ARCHITECT'S SUPPLEMENTAL INSTRUCTIONS

PROJECT:	The Residence at Green Meadow New Senior Development San Angelo, TX	Report No.	Seven (7)
OWNER:	Overland Property Group Dan Maximuk 234 N. Santa Fe Ave, Suite A Salina, KS 67401	Date	July 9, 2025
CONTRACTOR:	MCP Group 3501 SW Fairlawn Rd. Topeka, KS 66614	Architect's Proj No.	24-3395
		Contract For:	General Construction Mechanical, Electrical

A REFLECTED CLG
SECOND FLOOR PLAN
1/8" = 1'-0" 9,207 SF

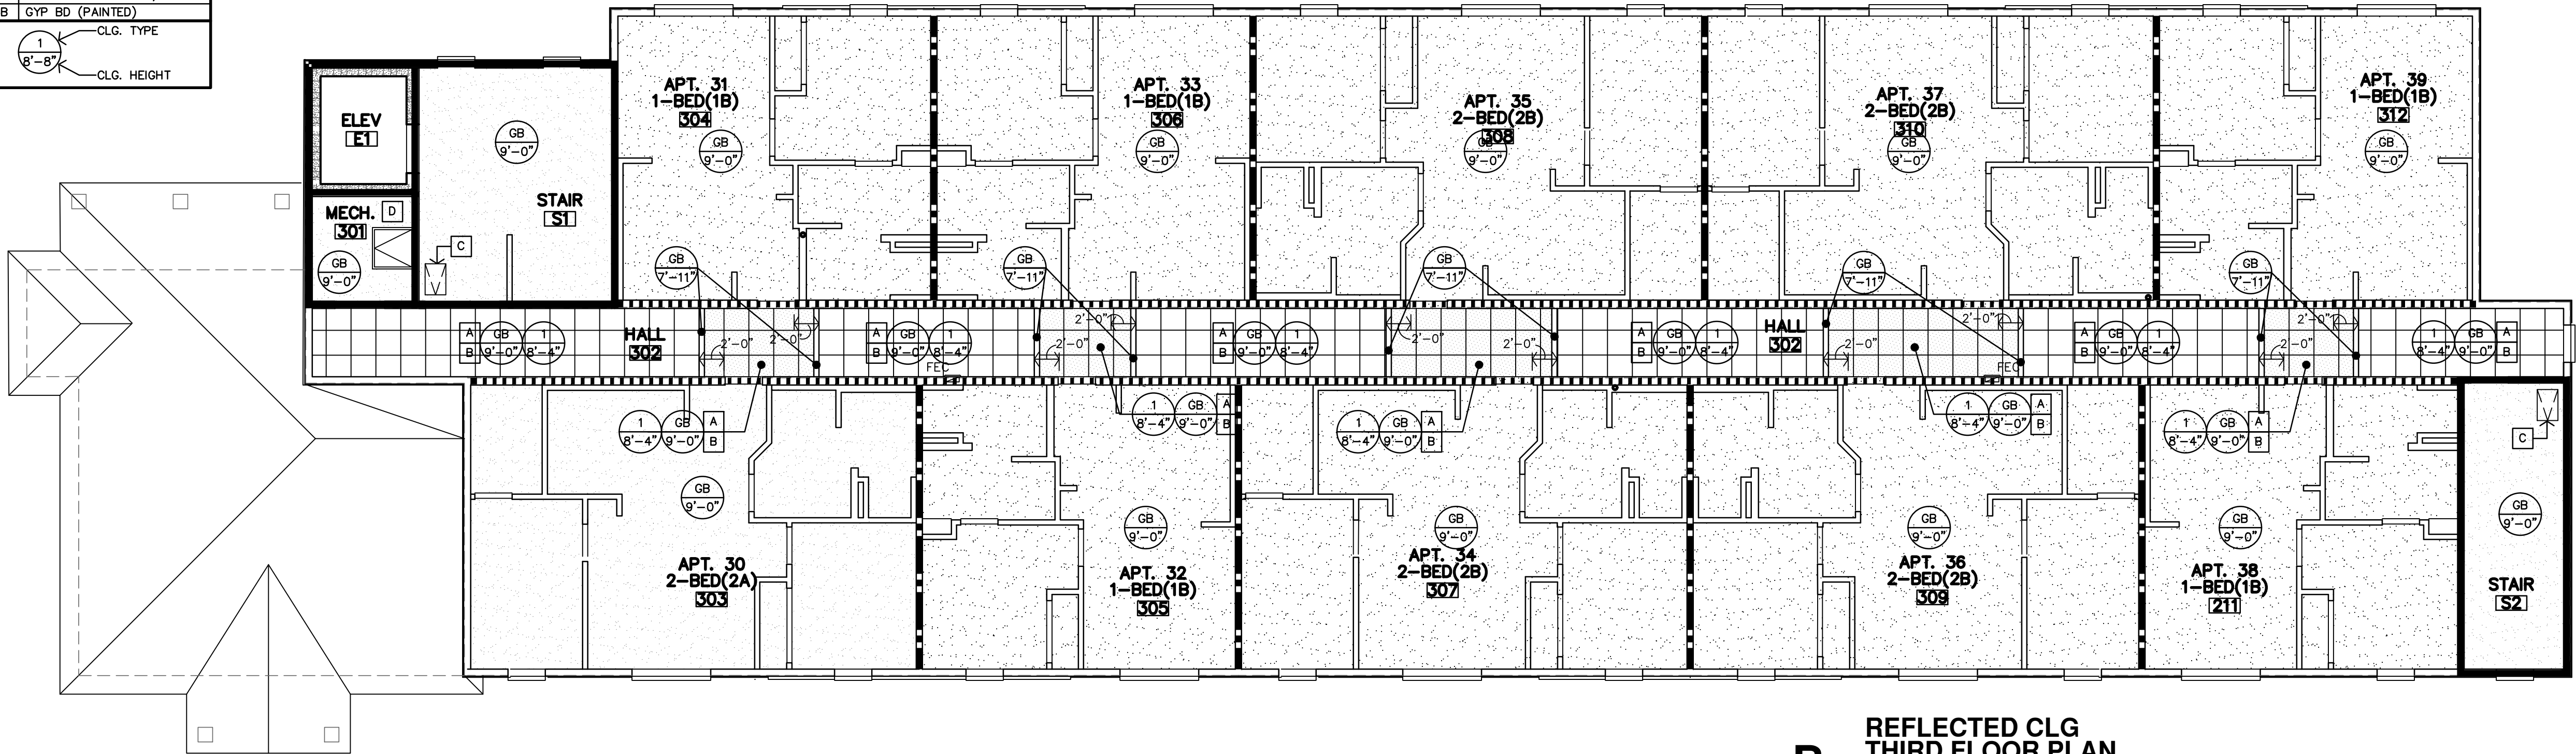
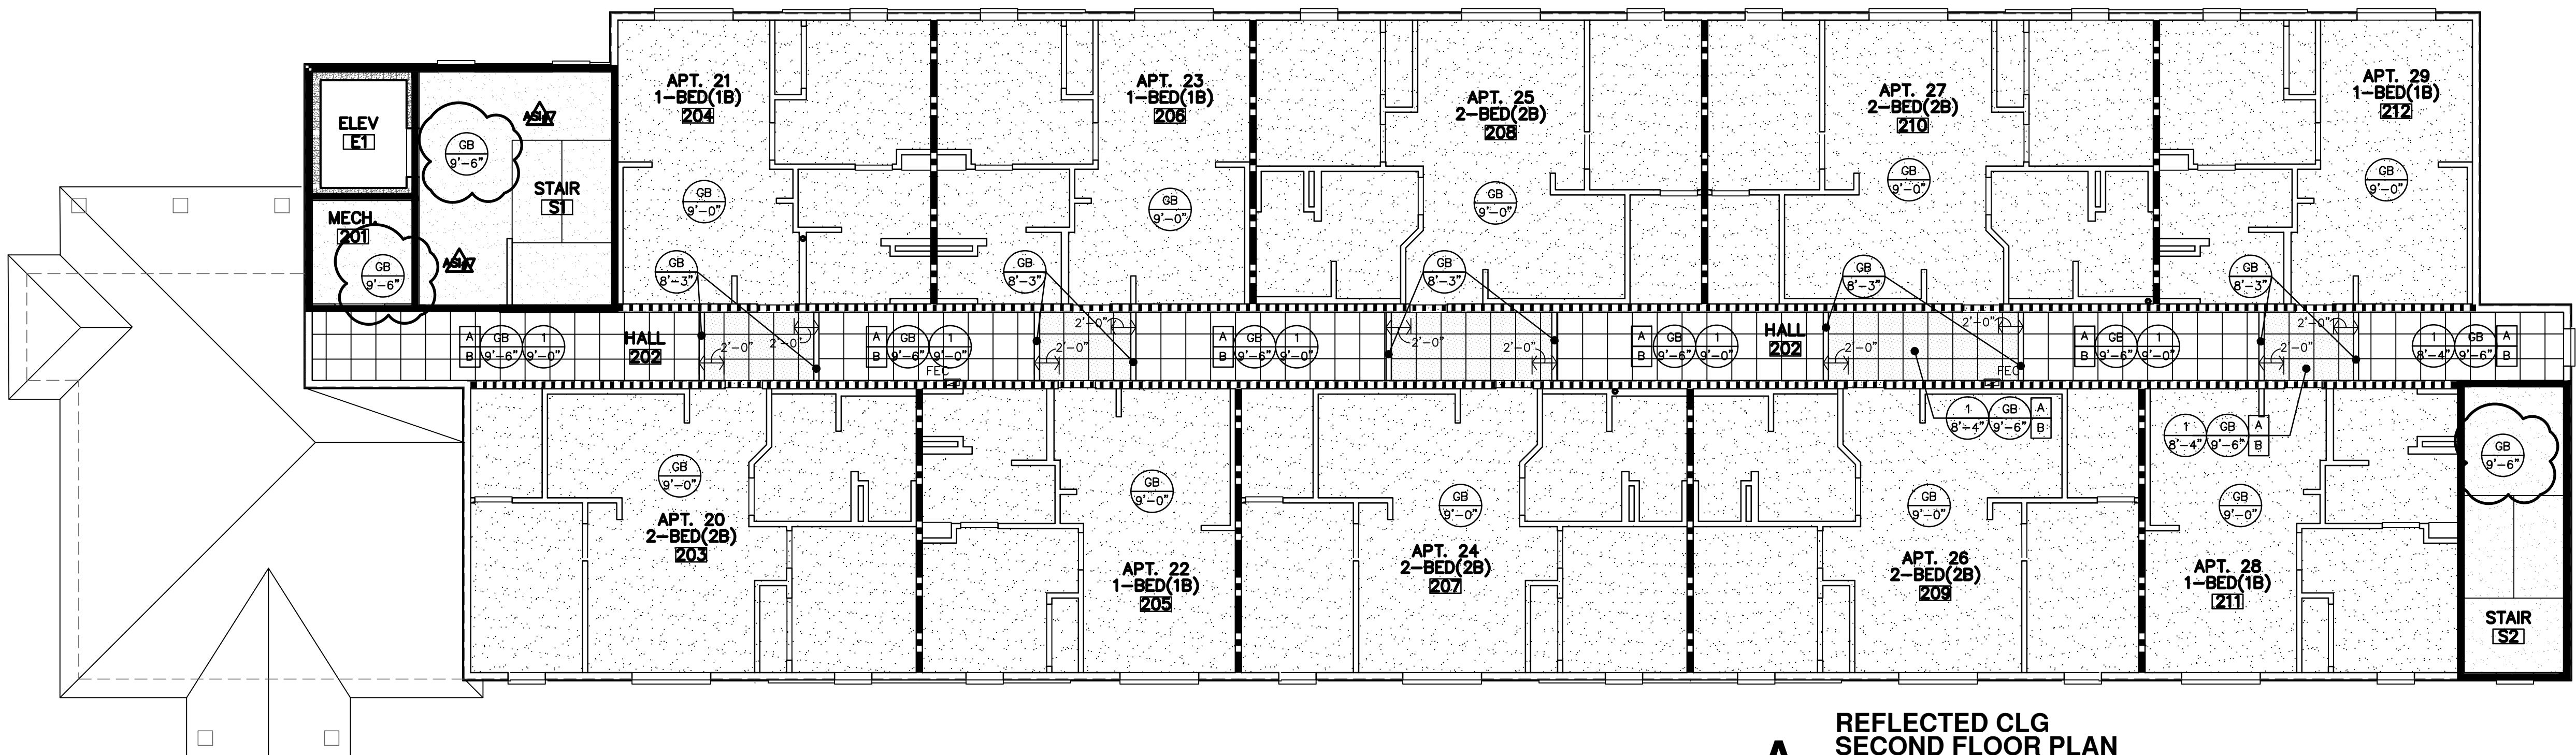
1. Ceilings at S1 and S2, shall be gyp. board over resilient channels, attached directly to joists above. Ceiling will be approx. 9'-6" a.f.f on floors 1 & 2, and approx. 9'-0" a.f.f on floor 3. Reference revised Sheets A7.1 and A7.2.
2. Stair S1
 - a. Detail D-A6.2 has been added to show the finish treatment around the steel beams.
 - b. Details D, E & F-A6.1 have been modified to show the location of the steel column. Extend the wing wall out around the column. The wall should be thickened to a 2x6 wall in lieu of a 2x4 wall.
3. Stairs S1 & S2
 - a. Sheet A6.3 and Details A & B-A6.3 have been added to show the finish underneath the stringers at the first floor.
